Subject: Liquefaction Analysis - Midland

SUBJECT: CORP OF ENGINEERS REPORT AND REQUEST FOR ADDITIONAL INFORMATION  
ON PLANT FILL

SUBJECT: Interagency Agreement No. NRC-03-79-167, Task No. 1 - Midland Plant  
Units 1 and 2, Subtask No. 1 - Letter Report

SUBJECT: Effect of Plant Fill on Seismic Ground Motion Environment at the  
Midland Michigan Nuclear Power Plant

Figure 15. Ratios of Response Spectra Calculated for Till Outcrop Cases

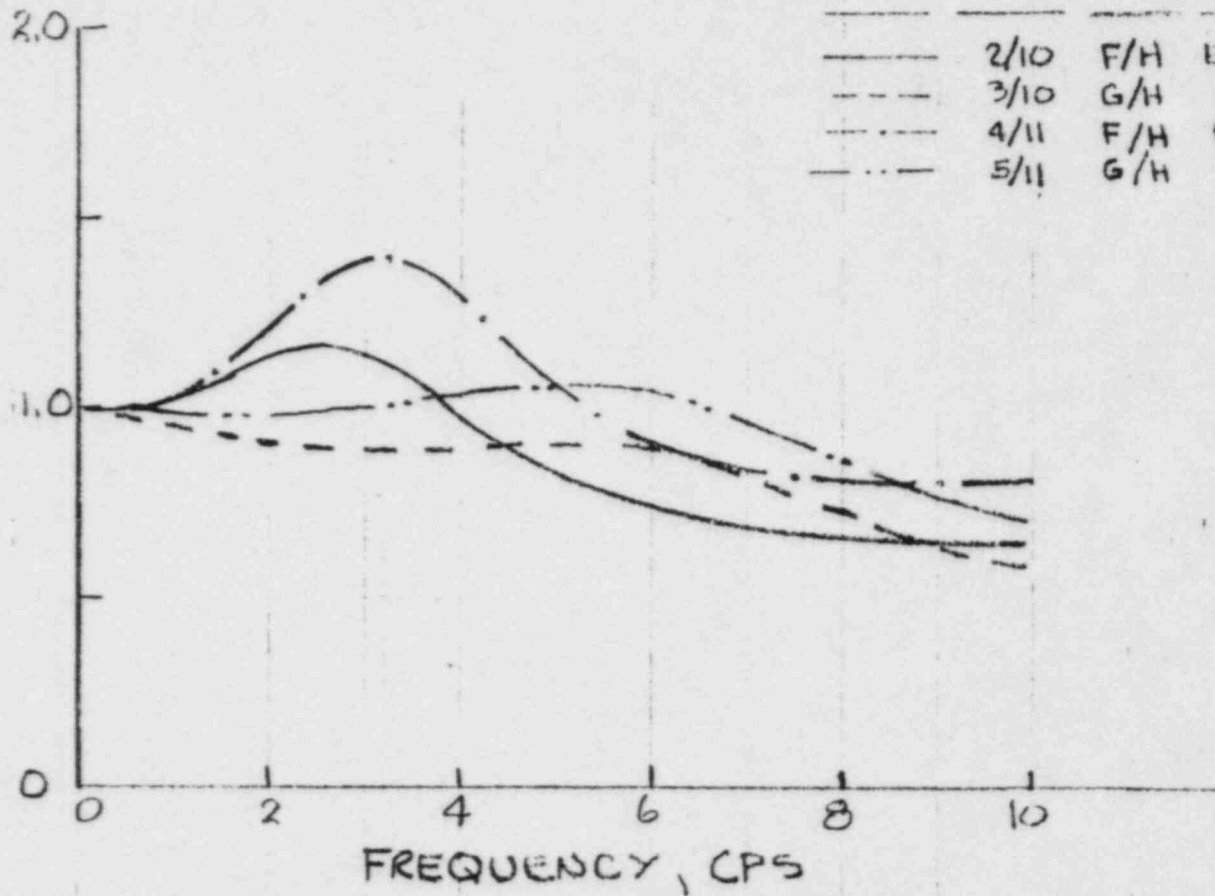
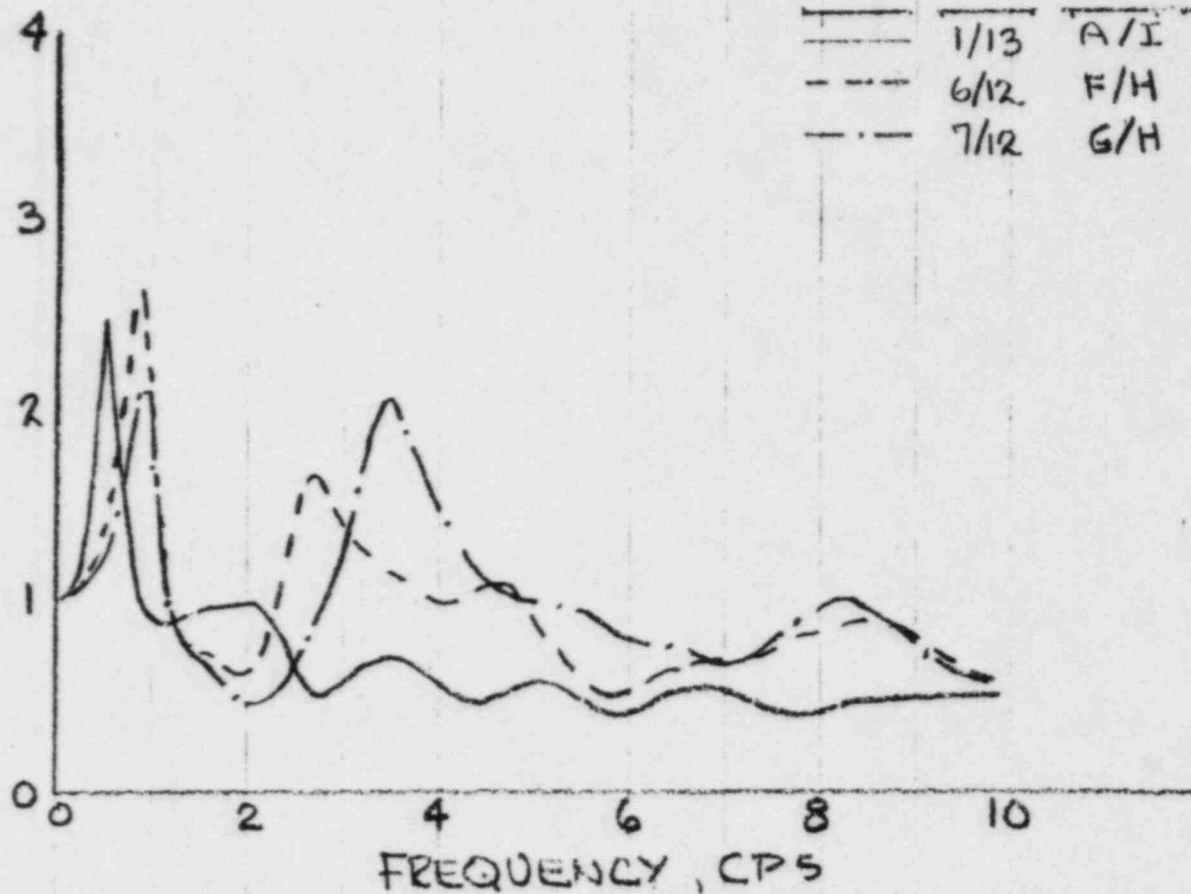
23. Figures 15 and 16 show ratios of response spectra calculated by the same equation used in Reference 3. These ratios are the ratio of the spectra for the top of fill to that for the outcrop motion. With only one exception, those cases where the writer judged the outcrop layer was reasonably matched to the actual conditions at the accelerograph secondary station are shown. The exception is the case of Runs 1 and 13 on Figure 16. This is shown because it was one of the cases examined in Reference 3. While the new calculation is close to the results in Figure B-14 of Reference 3, it is not an exact match. This is probably because the calculations which resulted in Figures 15 and 16 were performed with an amplification factor data set which had less resolution in the frequency domain ( $\Delta f = 0.1 \text{ Hz}$ ) and no smoothing of the input. The key point is that except for the cases involving the Parkfield-Temblor record, all lie

well below the curve for the ratios of site specific response spectra given in Figure 9 of Reference 3 (also Figure 5 of this memorandum). It is also of interest to note that the ratios are generally closer to unity over the entire frequency range for the till outcrop cases than for those with the Saginaw outcrop.
